Access Compliance Report

Public Rights-of-Way

(Curb Ramps)

Intersection ID: 7993	Main Street: AMERON_DR	Cross Street: N_GRAHAM_ST	Location: NE
ADA ID: C89A33888FEB	Ramp Type: Perp	Initial Pass/Fail: Fail	Overall Compliance: No
Severity Score: 25			
Codes/Mitigation Info/Possible Solution		Field Measurements/Component Compliance

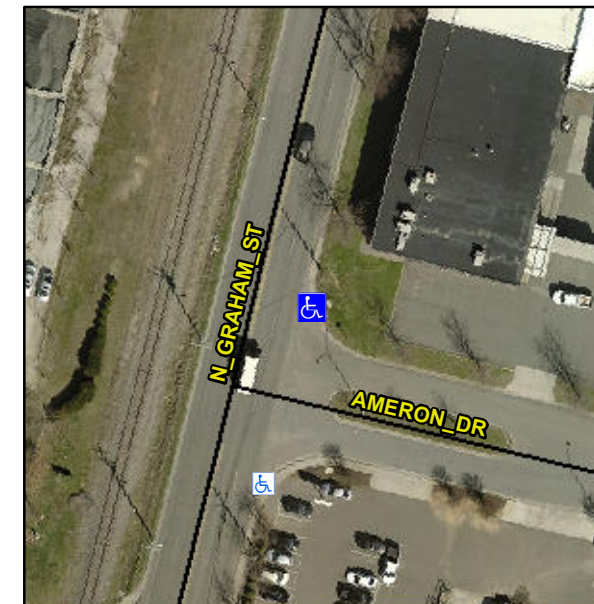
Remove & Replace Entire Ramp.

Not Found, R304.2.2

Compliance	Description	Data	Compliance	Description	Data
N/A	Ramp Length (in)	59.5	No	Ramp Slope (%)	12.6
Yes	Ramp Width (in)	50.0	Yes	Ramp XSlope (%)	0.5
N/A	Flare Type LT	N/A	N/A	Flare Type RT	N/A
N/A	Flare Slope LT (%)	N/A	N/A	Flare Slope RT (%)	N/A
N/A	Flare Traversable LT?	N/A	N/A	Flare Traversable RT?	N/A
N/A	Landing Length (in)	N/A	N/A	DWS Provided?	N/A
N/A	Landing Width (in)	N/A	N/A	DWS Contrast?	N/A
N/A	Landing Slope (%)	N/A	N/A	DWS Length (in)	N/A
N/A	Landing X Slope (%)	N/A	N/A	DWS Full Width?	N/A
N/A	Landing Curb? (Y/N)	N/A	N/A	DWS Offset (in)	N/A
N/A	Shared Landing?	N/A			
N/A	Gutter Ponding?	N/A	N/A	Gutter Slope (%)	N/A
N/A	Gutter Lip Ht (in)	N/A	N/A	Gutter X Slope (%)	N/A
N/A	Painted X Walk1?	No	N/A	Painted X Walk2?	N/A
	X Walk 1 Direction	To SW		X Walk 2 Direction	N/A
N/A	X Walk 1 Width (in)	N/A	N/A	X Walk 2 Width (in)	N/A
	X Walk 1 Slope (%)	0.5		X Walk 2 Slope (%)	N/A
	X Walk 1 X Slope (%)	0.7		X Walk 2 X Slope (%)	N/A
